Jan. 23rd, 2018

This letter is in response to your mail dated on Jan 23rd, 2018 regarding your second request for additional information for our exempt distribution license.

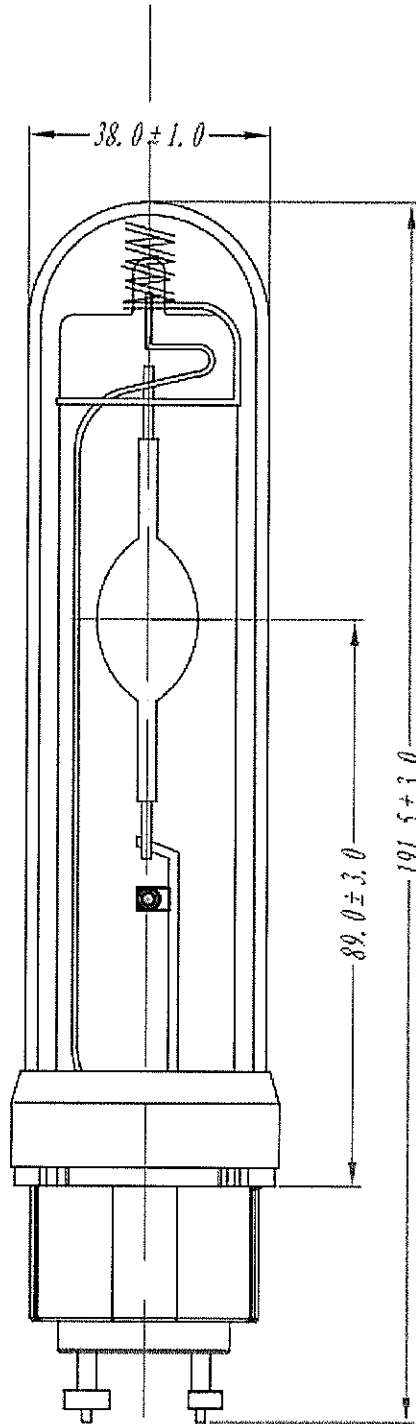
5. Please provide examples of your labels in the form of drawings, copies, or photographs.

I am attaching a picture with Kr-85 labeling on the bubble pack containing the electron tube.
